The TOWNSHIP of NORTH DUMFRIES

model
36-02

project #
17052

project
Legacy

BASEMENT FLOOR ELEV. 'A' & 'B'

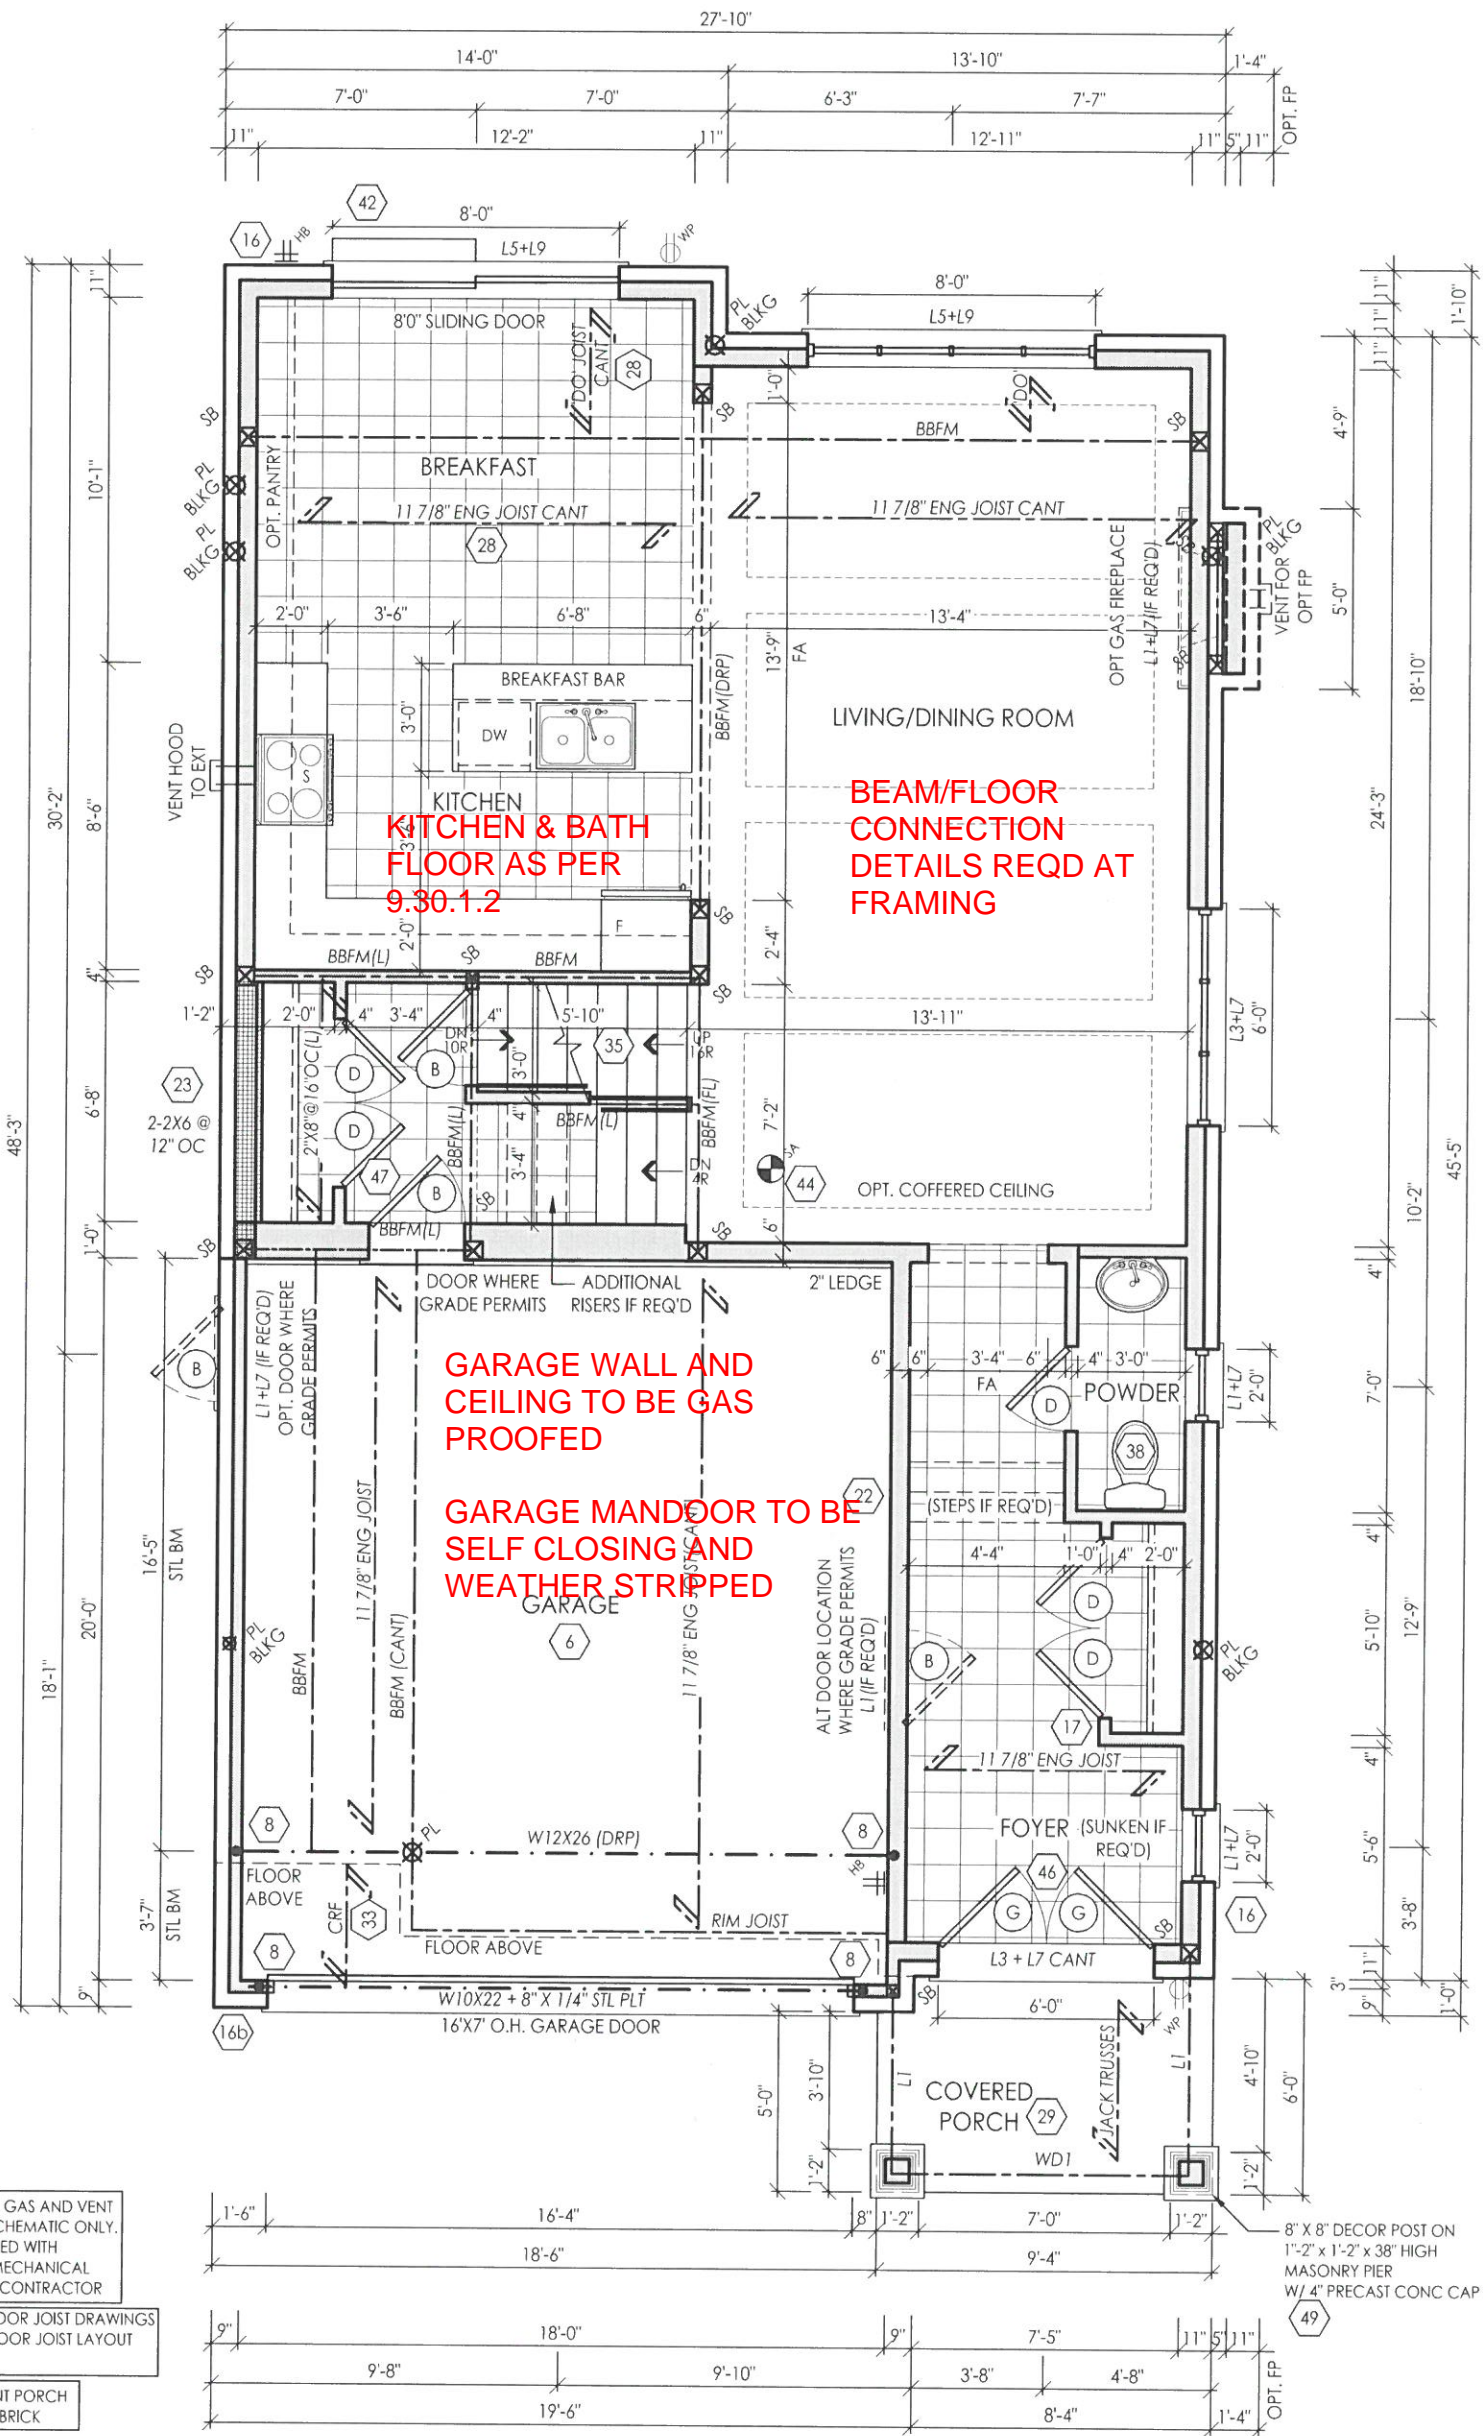
**BASEMENT AIR BARRIER
SUMP LIDS, JOINTS AT
INTERSECTIONS AND ALL
PENETRATIONS OF SLAB MUST
BE SEALED TO PREVENT AIR
LEAKAGE**

**SEPARATE
PERMIT REQD
TO FINISH BSMT**

**SUMP PIT
INSTALLED AND
CONNECTED**

**6'11 CEILING
HEIGHT REQD
OVER 75% OF BSMT
SPACE AS PER 9.5.3**

**COLD CELLAR DOOR TO BE
INSULATED AND WEATHER STRIPPED**

GROUND FLOOR ELEV. 'B'

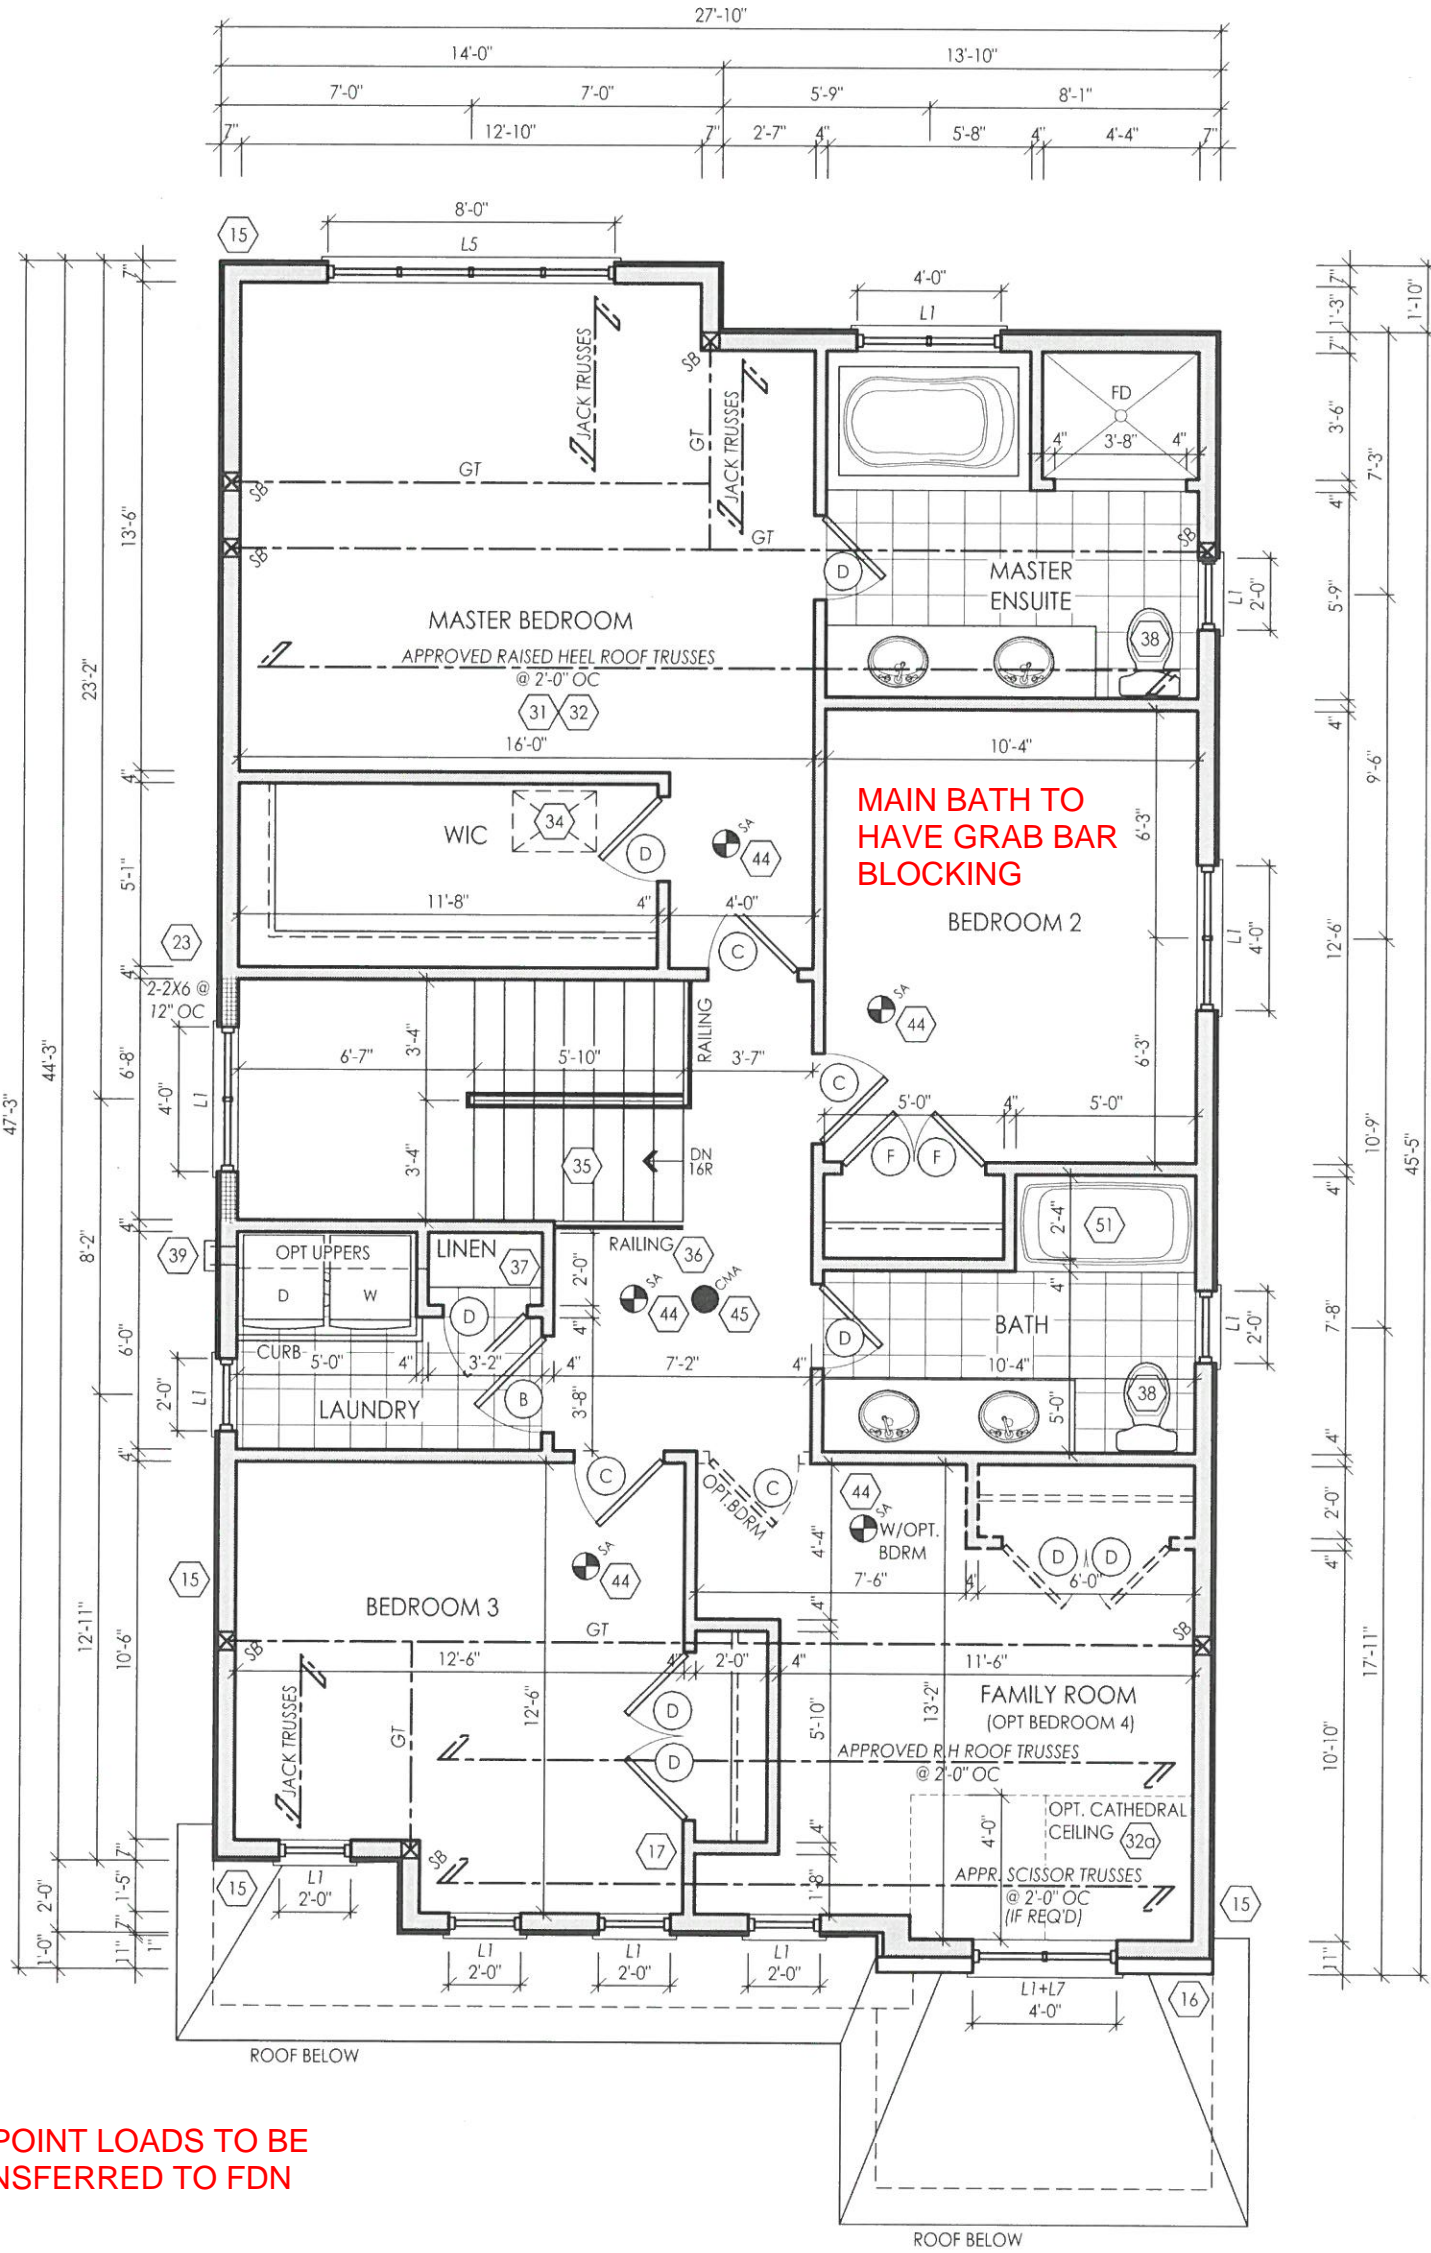
BEAM AND LINTEL
SIZES TO BE NOTED ON
FUTURE PLANS

LINTEL PACKAGE AND ENGINEERED BEAM
DETAILS TO BE SUBMITTED PRIOR TO
FRAMING INSPECTION

SECOND FLOOR ELEV. 'B'

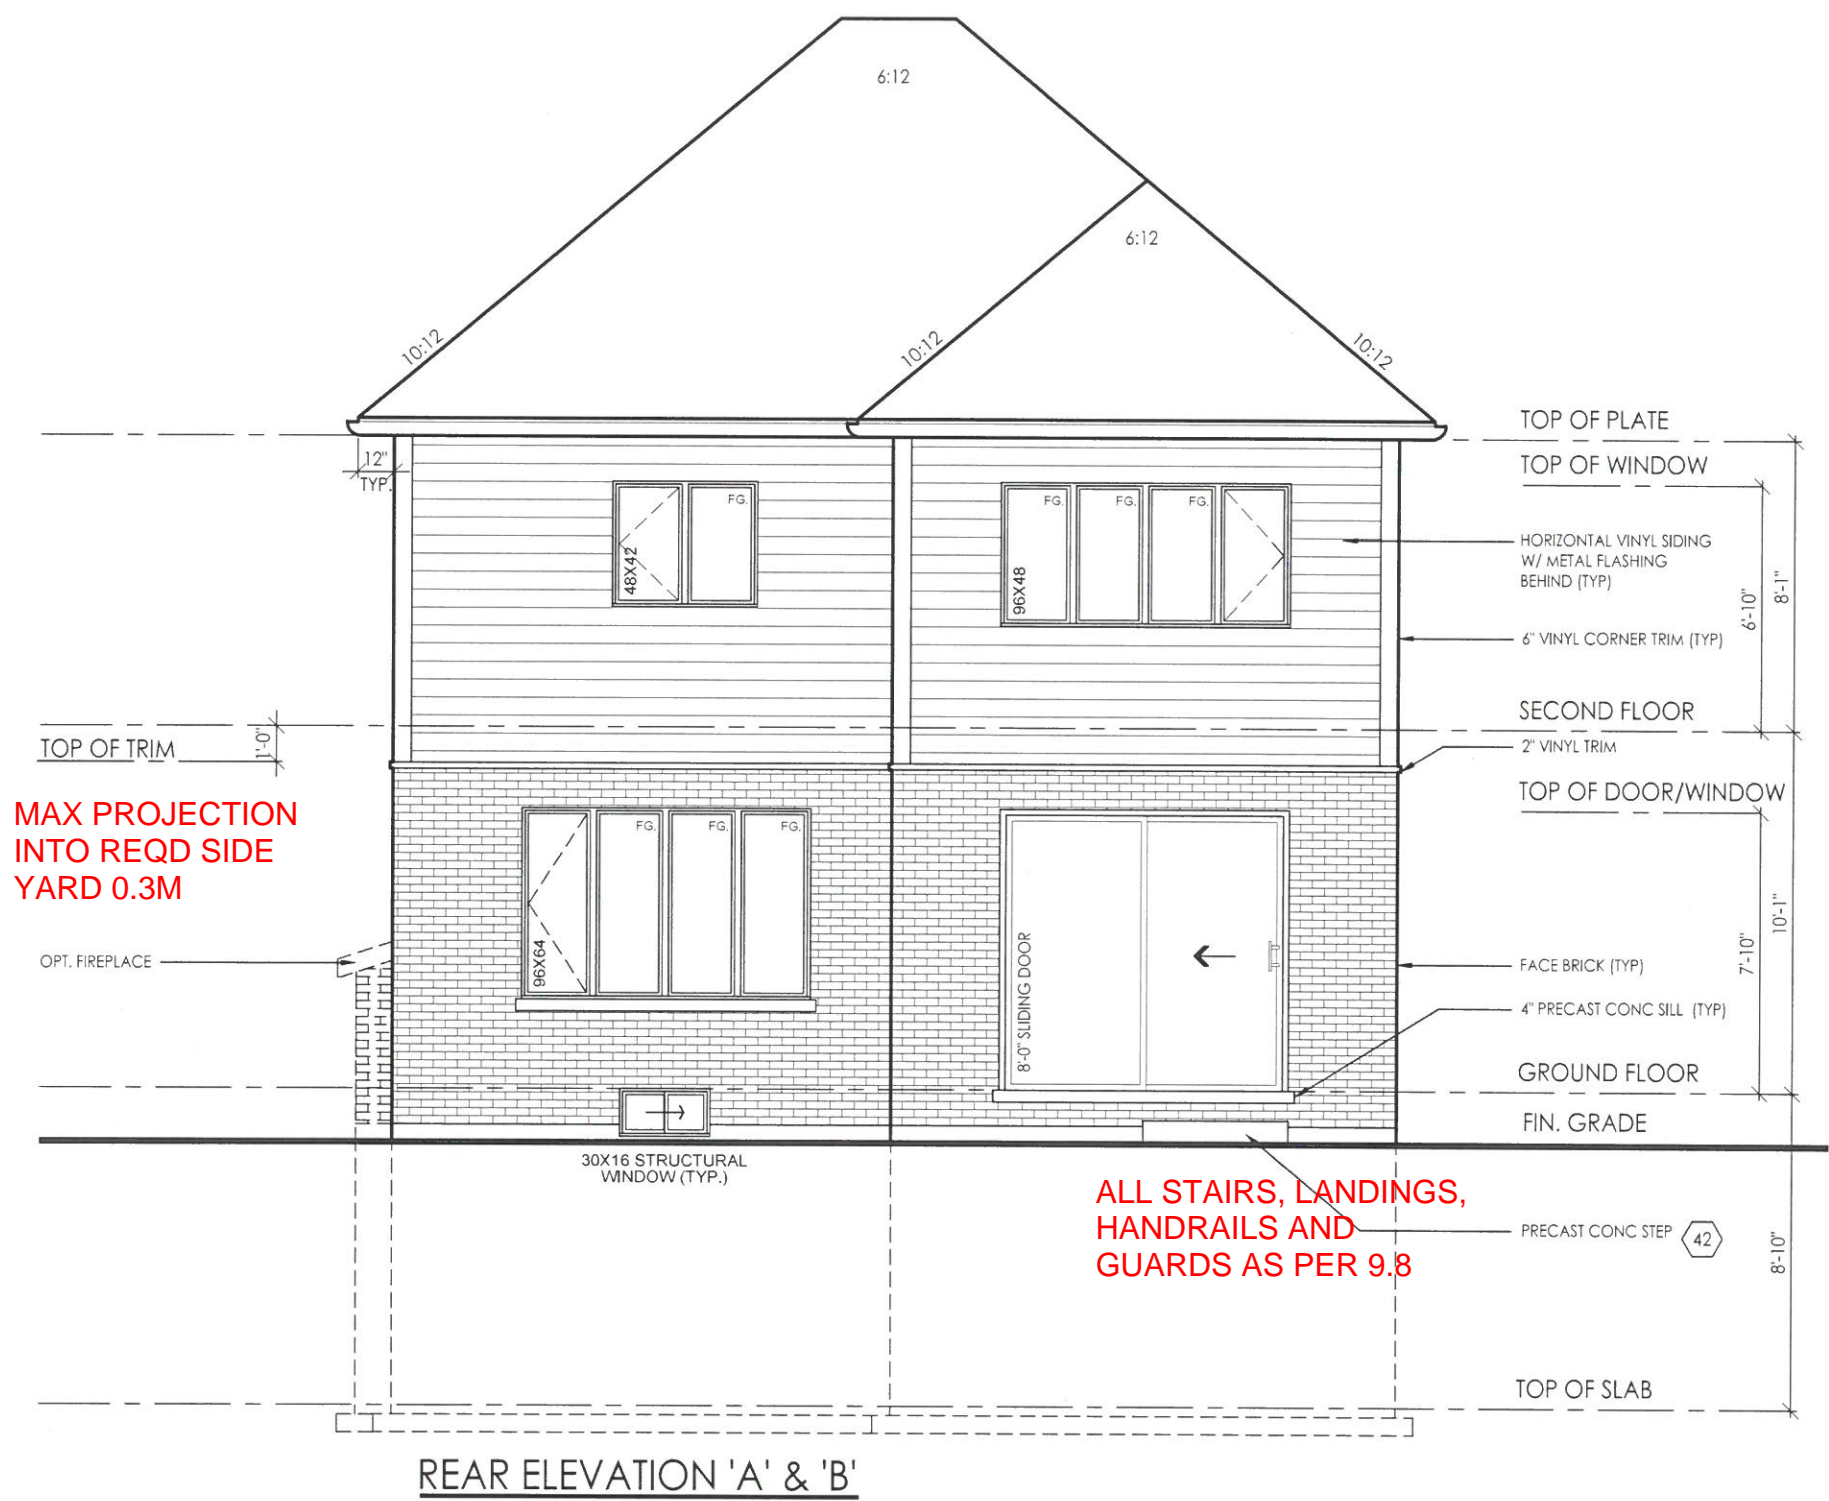
ENGINEERED FLOOR LAYOUT, TRUSSES AND LINTELS TO BE SUBMITTED PRIOR TO FRAMING. DESIGNER TO COMPLETE RESPONSIBILITY REVIEW FORM AND TO BE SUBMITTED WITH TRUSS, FLOOR AND LINTEL DOCUMENTS.

WINDOW ON LANDING MUST BE HIGHER THAN 3' ABOVE OR ENGINEERING ON WINDOW OR GUARD REQD
